DASY8/6 Module WPT

PIA INQUIRY

Compliance Testing against SAR
and MPE Limits (V1.2 August 2025)

**A Response to FCC's Questions/Comments about KDB Inquiry 959118
(Apr. 3, 2024)**

Figure 1: Module WPT procedure for validation and assessment of the uncertainty of the field reconstruction.

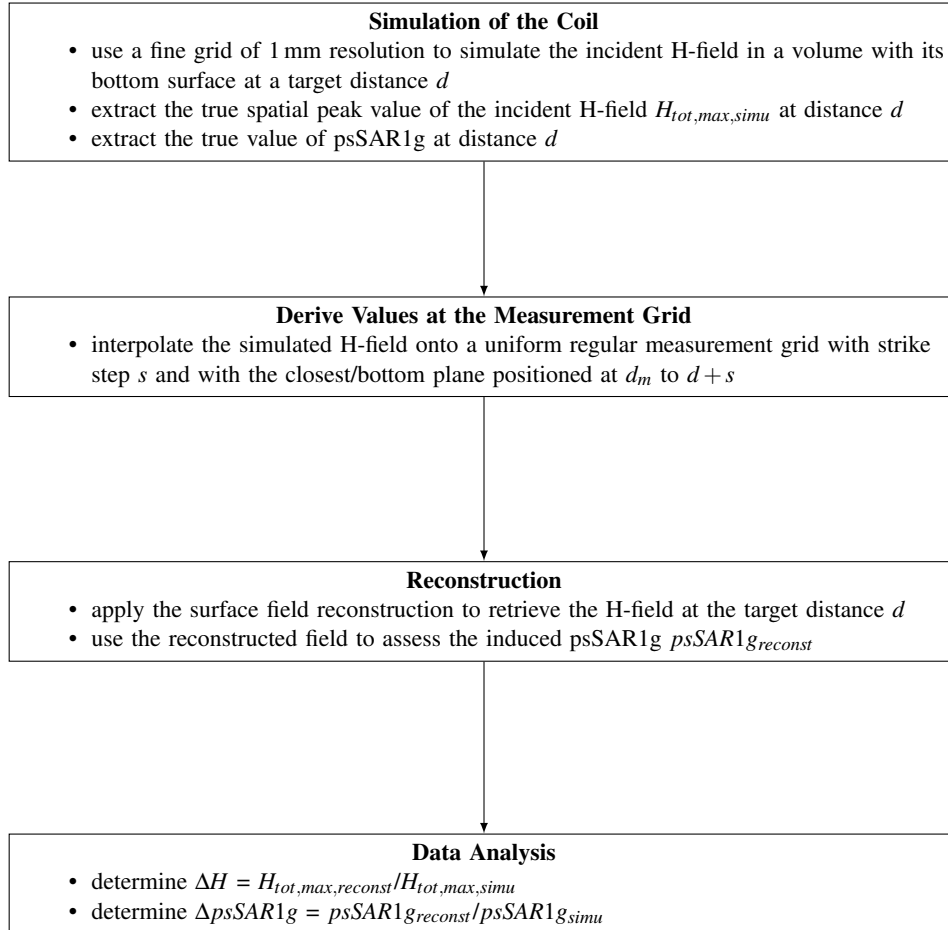
We would like to see details on the validation when this estimate is conducted for the point where the actual field was measured exactly, that is where the probe center can actually be placed (as discussed in the mentioned KDB Pub.).

While we expect that this measurement will work quite well for coils that provide a relatively uniform field along the axis over a characteristic length in the order of the radius of the probe, it would be interesting to see what could be a more challenging case for smaller coils, where the field lines are expected to exhibit a more pronounced to turn off-axis, even at the small distance of the probe radius.

In other words, let's consider r the radius of the probe, R the radius of the coil located in $z=0$ with z being the direction of the coil axis; one can measure the field exactly by placing the center of the probe at $z=r$, and extrapolate the field at $z=0$ (contact position with the coil plane). If $R \gg r$, then the field lines will be relatively "straight" at $z=r$. But if $R \approx r$, the curvature of the field lines will be more pronounced, and one would expect a lesser accuracy of the field estimate at $z=0$.

This surface H-field reconstruction has been validated as documented in Appendix A. The assessed uncertainty is 0.6 dB ($k = 2$), and the full uncertainty budget is provided in Section 6.2 of the Module WPT manual [3].

The surface field reconstruction method has been validated for different distances from the coil by comparing the H-field and induced SAR reconstructed on the basis of values simulated on a uniform regular measurement grid to the values determined from simulations. The diameter of the coil geometry is varied from 50 mm to 450 mm, and the filling ratio ranges from 0.1 to 0.9. The detailed assessment workflow is illustrated in Figure 1.

The results demonstrate that the maximum difference between the reconstructed fields and their true values decreases as the grid step s becomes finer, especially for very localized sources. For the implemented grid step s of 7.33 mm in DASY8/6 Module WPT V2.4, ΔH ($k = 1$) is less than 0.3 dB and for $\Delta psSAR1g$ ($k = 1$) is less than 0.2 dB.

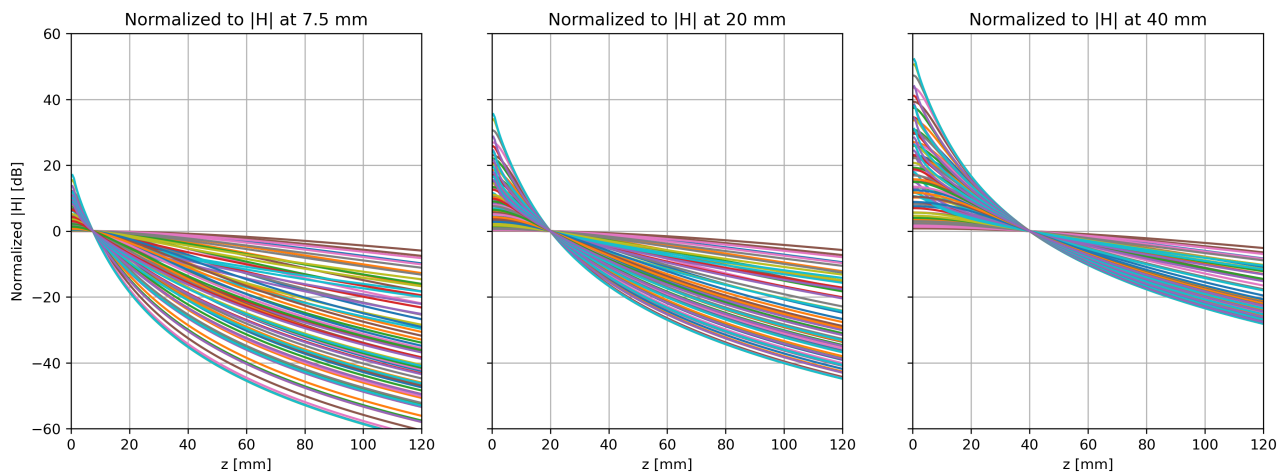
We outlined in the previous reply the validation of the extrapolation method (that is, using the probe without the field reconstruction), and we expanded that in more detail in the latest Apr 2024 TCBC workshop (Presentation 4.2).

Figure 1 shows that if we are able to measure the field accurately at 20 mm, the field at the surface is between 0 dB and 38 dB (1–80 times) of the value at 20 mm. If the field is accurately measured at 7.5 mm, the variation is reduced to 0 dB and 17 dB (1–7 times) of the value at 7.5 mm. In other words, the measurement at 7.5 mm is not sufficient to determine the field at the surface with an uncertainty of $\pm 30\%$ as requested by FCC [1].

We believe that the procedure meets the FCC criteria of $\pm 30\%$. It has been validated using several thousands different realistic H-field decays/profiles.

If we would measure as suggested at 7.5 mm and take another measurement with an offset of 7.5 mm (i.e., at 15 mm from the surface) and use this information to find an optimal extrapolation function to estimate the field at the surface, the results would be more accurate since the gradient would be more accurate. However, the final uncertainty would be prone to user errors and affected by the uncertainty of the 7.5 mm shift.
